Addendum No. 3

Owner: City of Unalaska

Project: **SEWAGE LIFT STATION #3 FORCE MAIN REPLACEMENT (FM)**
DELTA WAY STORM DRAIN (SD)
DPW Project No. 11503-01

Date: April 25, 2014

REGAN ENGINEERING, P.C.	
PROJECT:	CITY OF UNALASKA SEWAGE LIFT STATION #3 FORCE MAIN MAIN REPLACEMENT - DELTA WAY STORM DRAIN
TITLE:	SHEET LAYOUT, LEGEND, ABBREVIATIONS & NOTES
DESIGNED BY:	TR DATE: 03/24/14 SHEET NO:
CHECKED BY:	TR DPW PROJECT NO: 11503-01 C-2 of 10

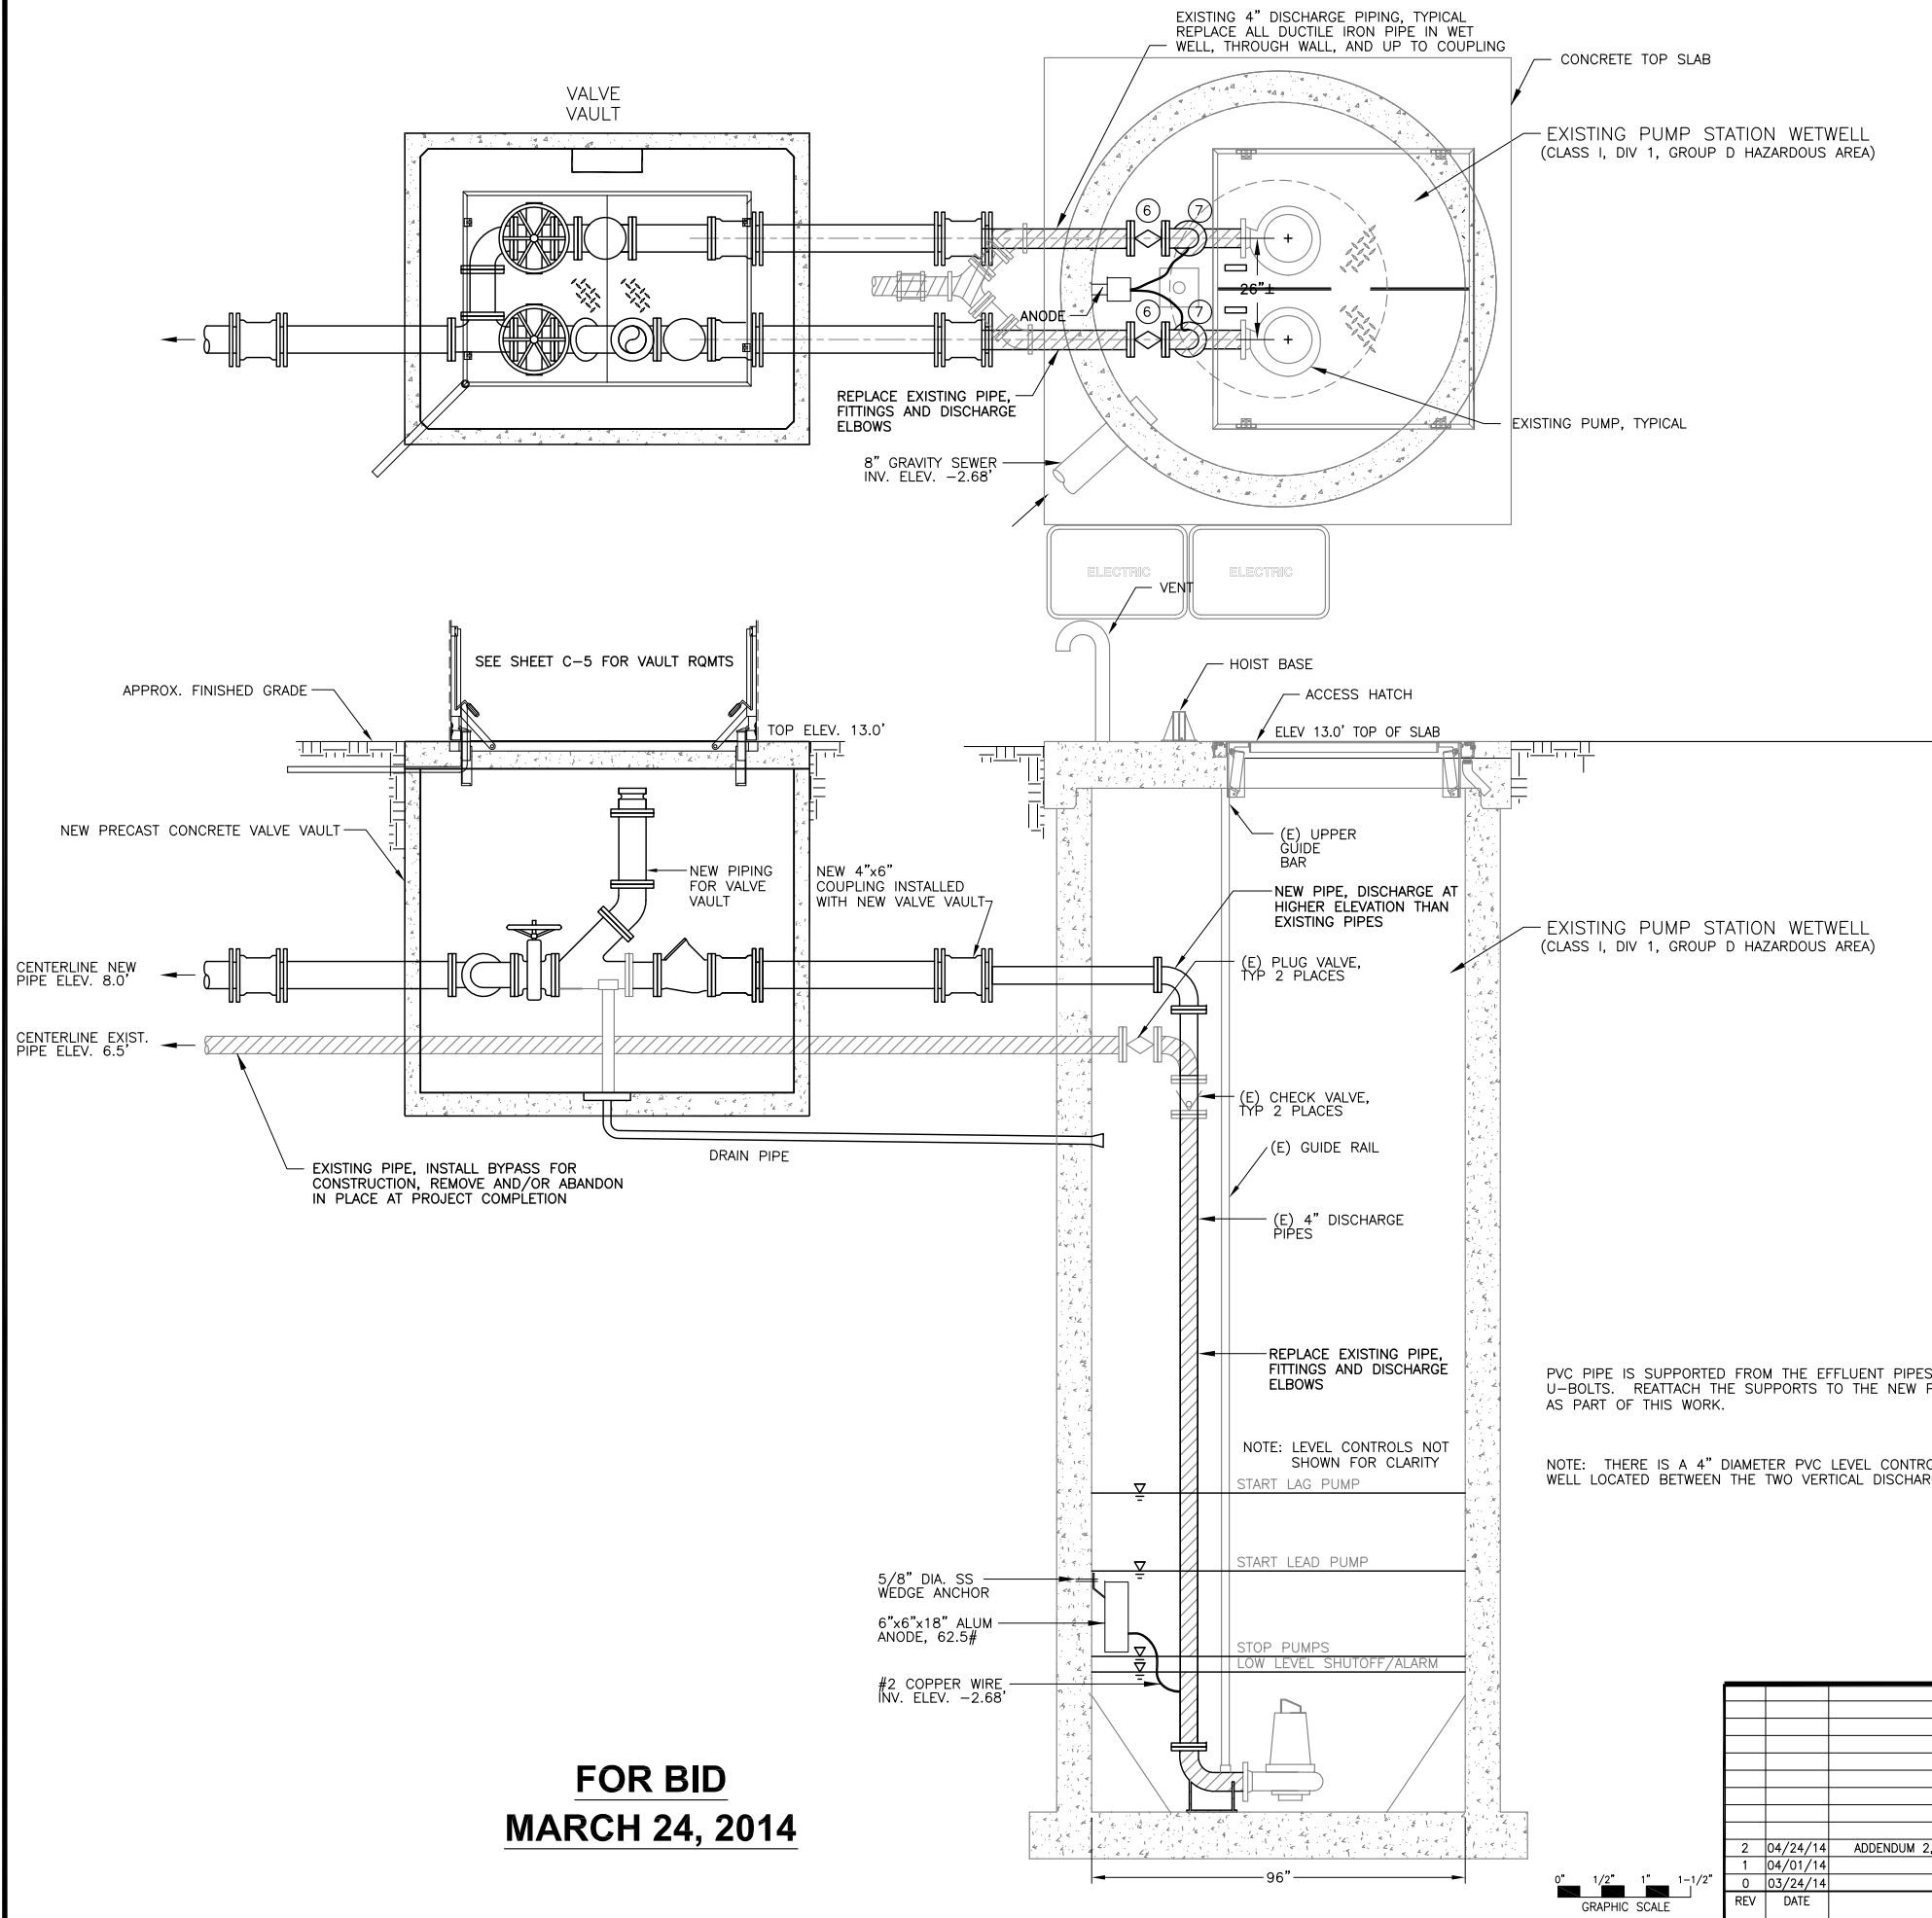
Item 6: DESIGN DRAWINGS, Sheet C-2 of 10, SHEET LAYOUT, LEGEND, ABBREVIATIONS & NOTES;

Delete this drawing in its entirety and replace it with the revised drawing C-2 attached to this addendum.

Narrative: The Cul-de-Sac on Willow Drive is offered as an alternative location to install the Contaminated Material Storage Cell. The ADEC approved the site provided the stockpile is fenced and signage is installed to preclude public access. If the Contractor opts to use this site, fencing and signage are added to the scope of services for Bid Item 9 on the Delta Way Storm Drain (SD) Bid Proposal. Fencing shall be 6' high chain link suitable to sufficiently prevent public access from the contaminated storage cell area.

DESIGNED BY: TR DATE: 03/24/14 SHEET NO: C-6 OF 10
CHECKED BY: TR DPW PROJECT NO: 11503-01

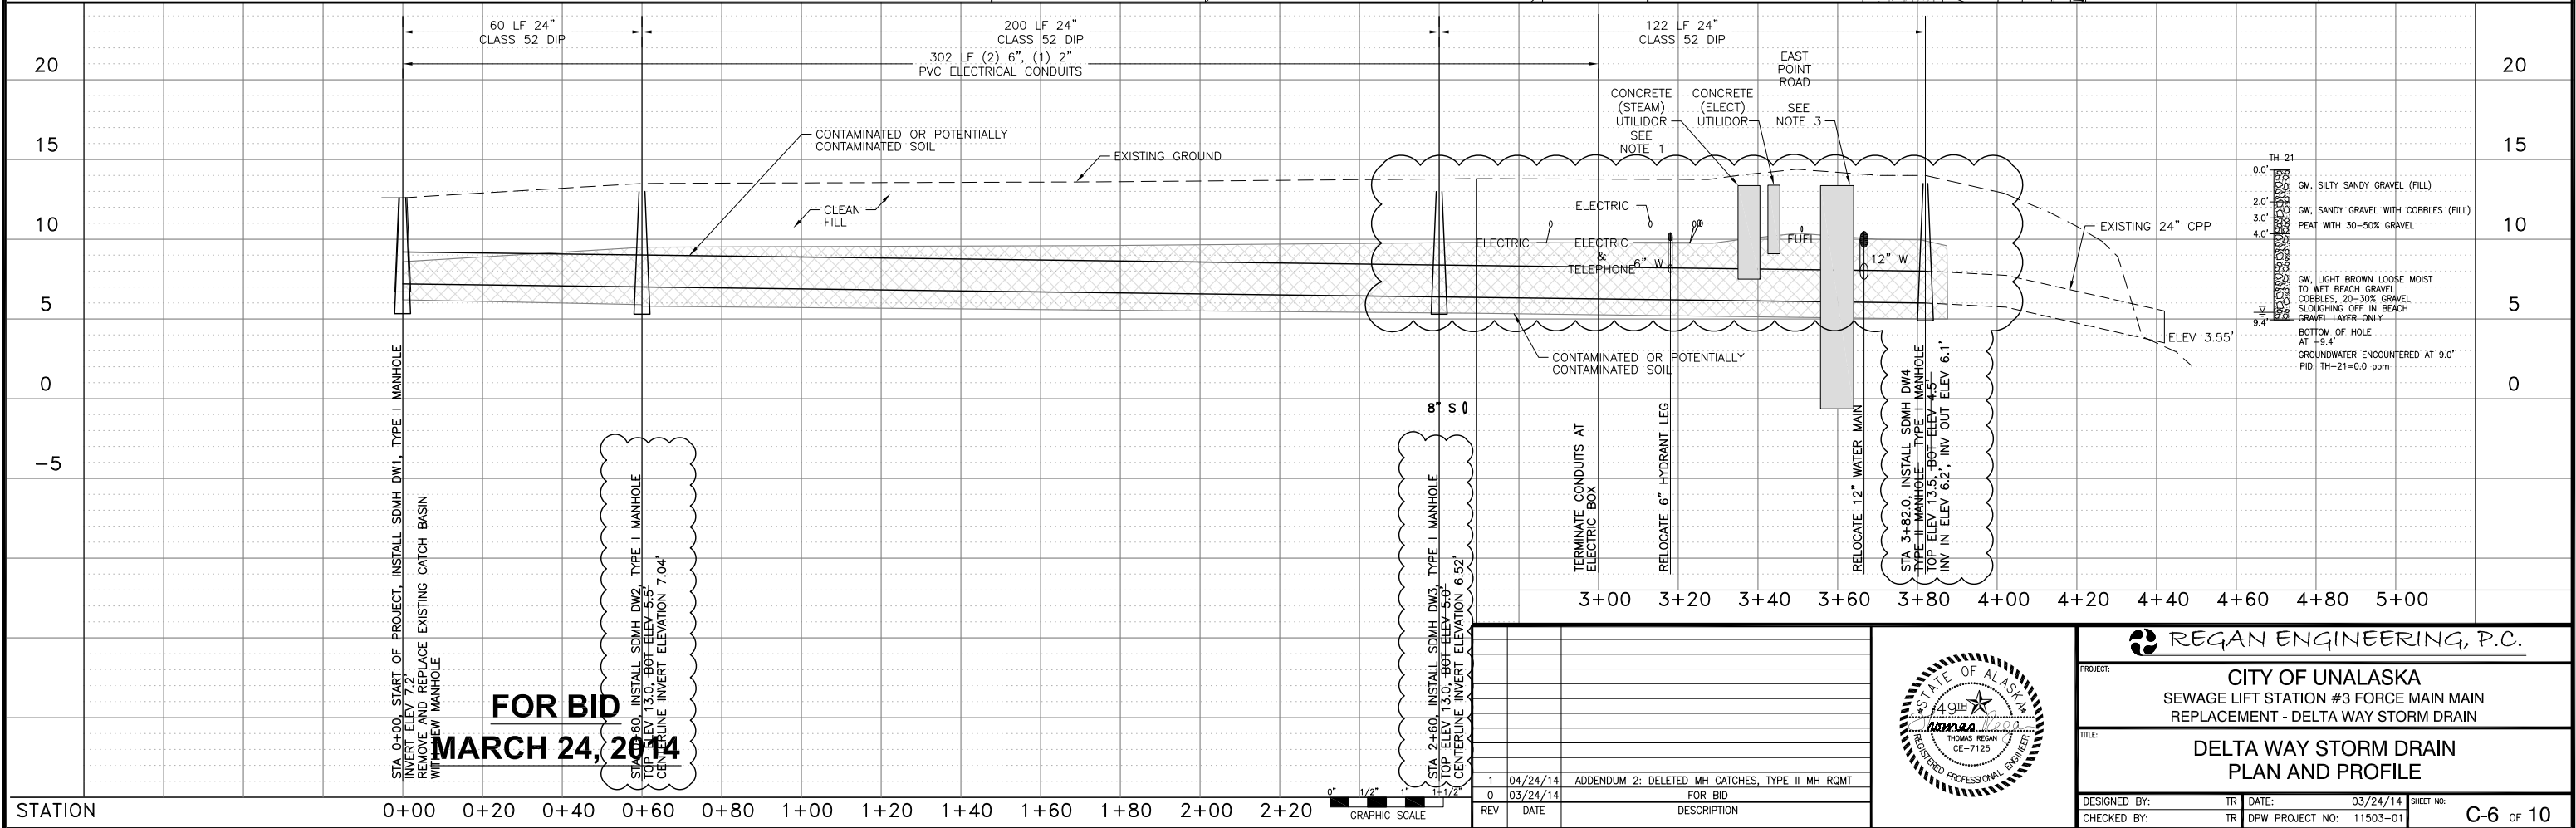
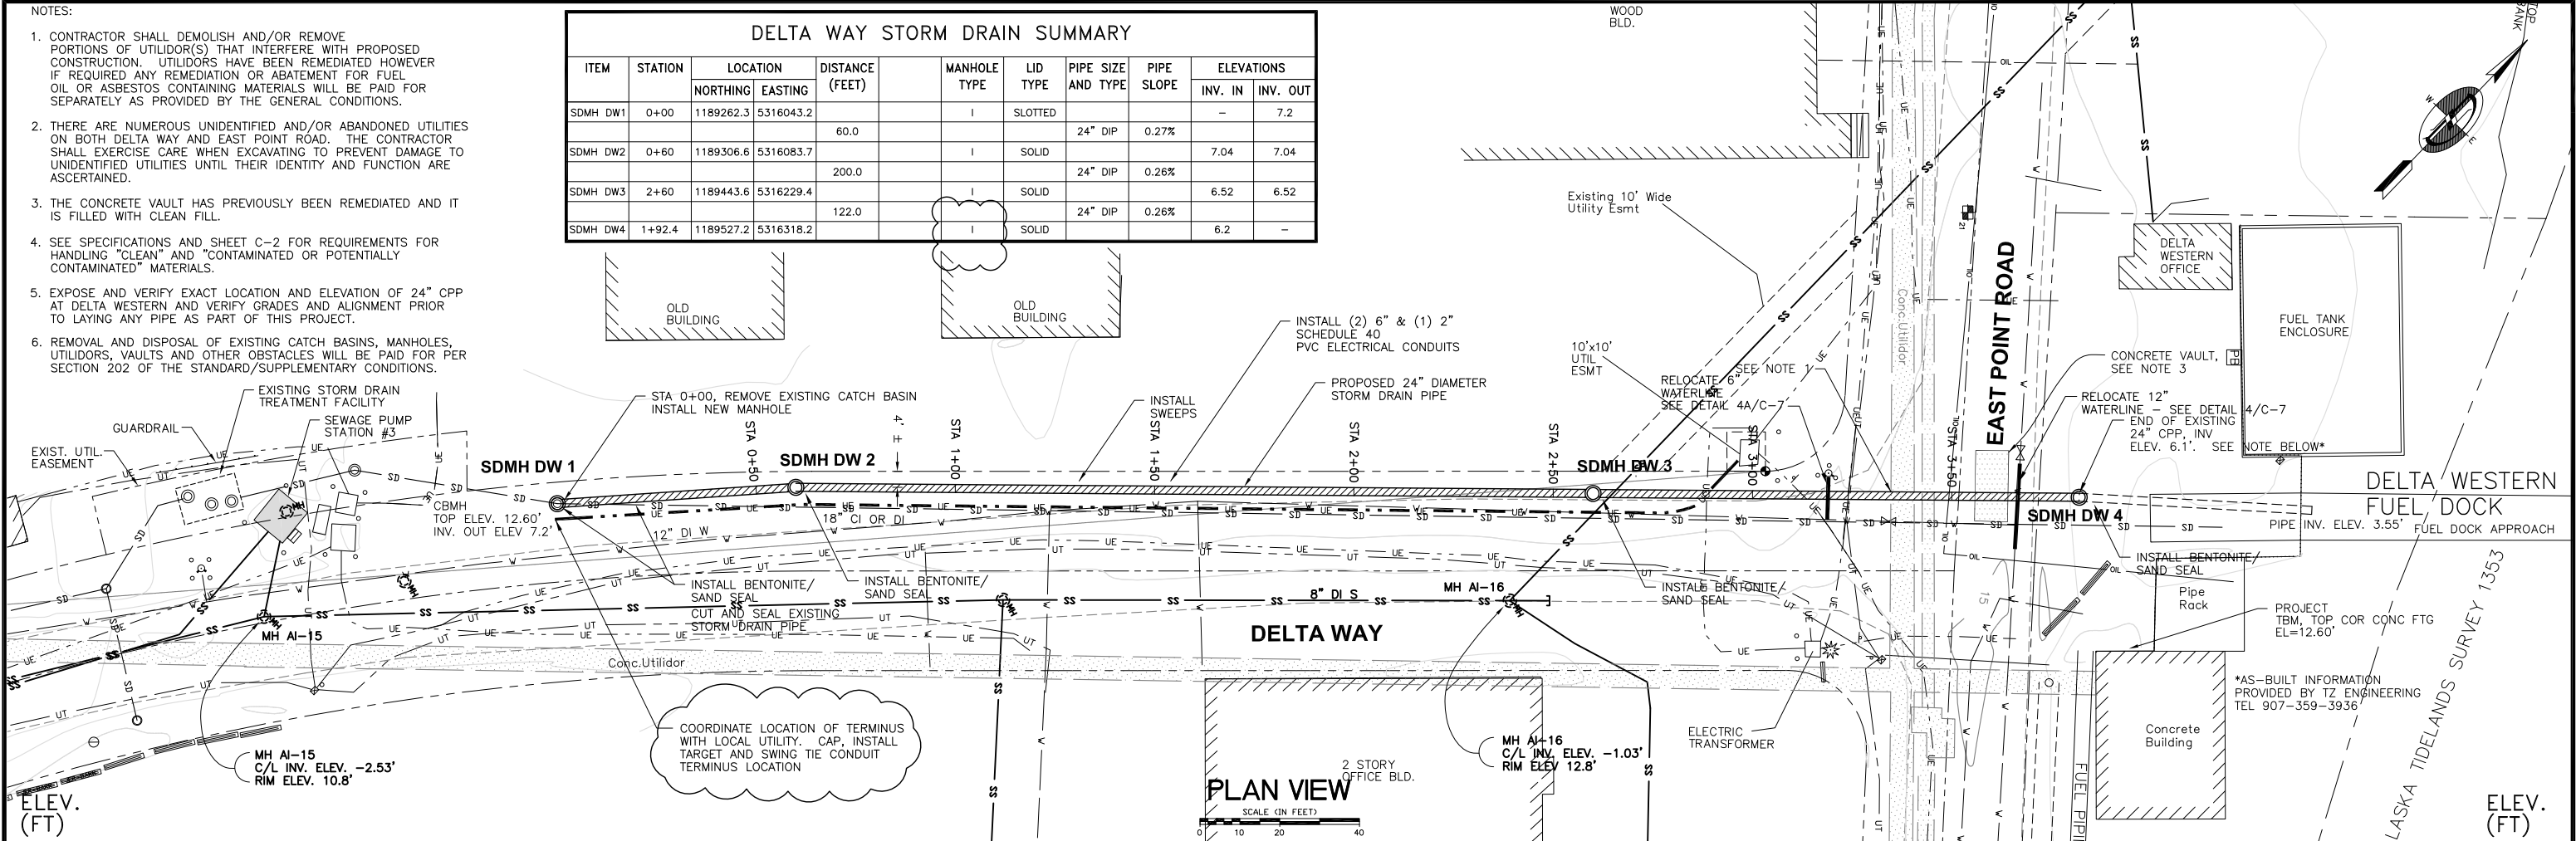
Item 9: DESIGN DRAWINGS, Sheet C-6 of 10, DELTA WAY STORM DRAIN PLAN AND PROFILE;

Delete this drawing in its entirety and replace it with the revised drawing C-6 attached to this addendum.

Narrative: The manhole base elevations were deleted from the profile to reflect elimination of the catch. MH DW-4 was changed from a Type II (6' diameter) to a Type I (4' diameter) manhole. The extent of the contaminated or potentially contaminated soils shown on the profile was modified. Everything above 4' depth has been pre-characterized to be clean material with the condition that visual/olfactory evidence of fuel requires treatment as contaminated or potentially contaminated material. The electrical conduits were moved for installation in a separate trench.

DESIGNED BY: TR DATE: 03/24/14 SHEET NO: C-7 of 10
CHECKED BY: TR DPW PROJECT NO: 11503-01

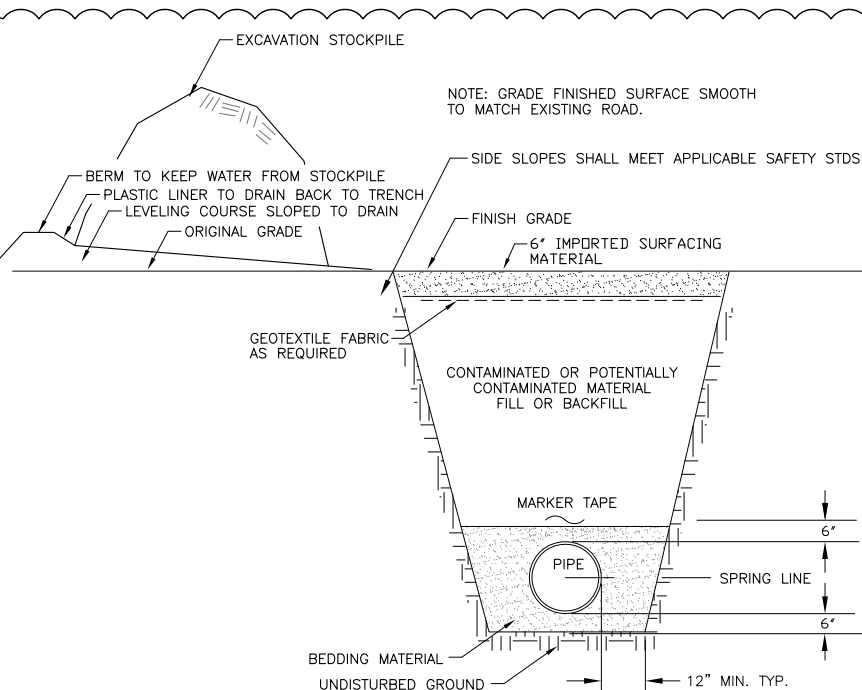
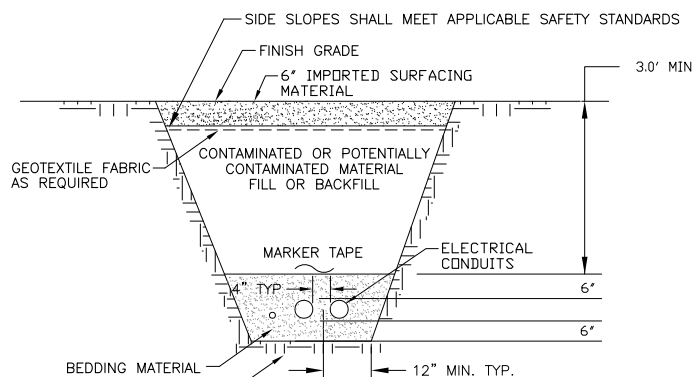
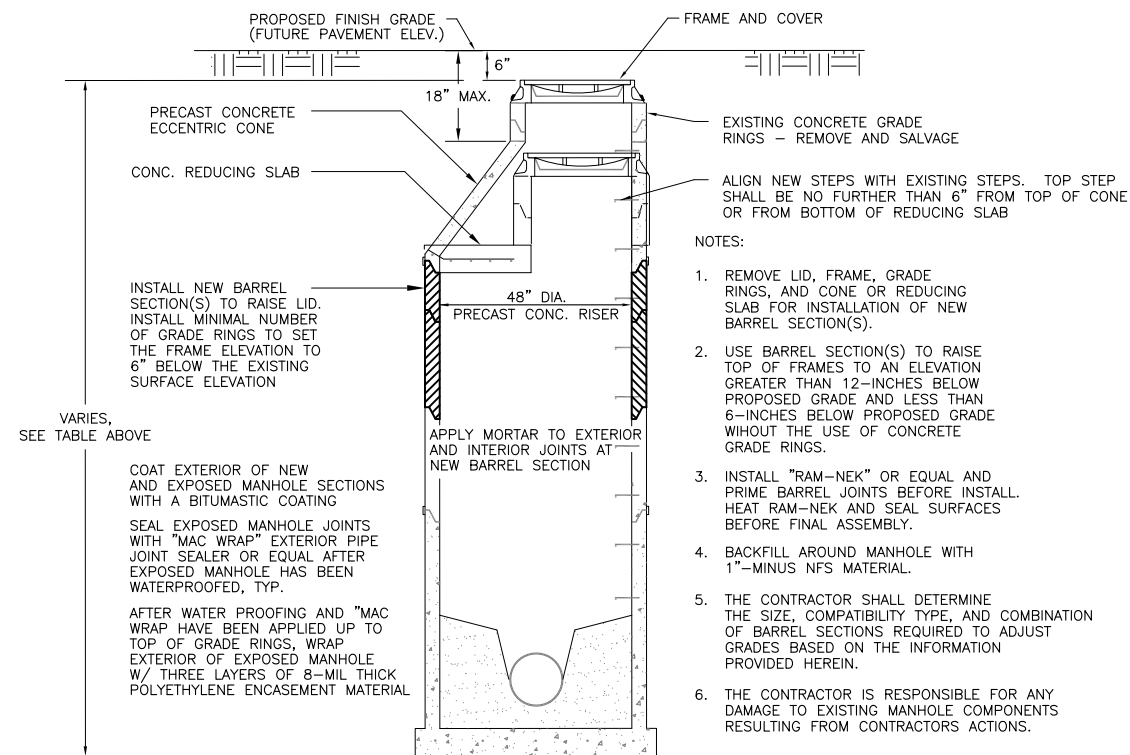
Item 10: DESIGN DRAWINGS, Sheet C-7 of 10 MISCELLANEOUS DETAILS;

Delete this drawing in its entirety and replace it with the revised drawing C-7 attached to this addendum.

Narrative: The electrical conduits were removed from the storm drain pipe trench with the intention of installing them in their own trench. A separate trench section was added.
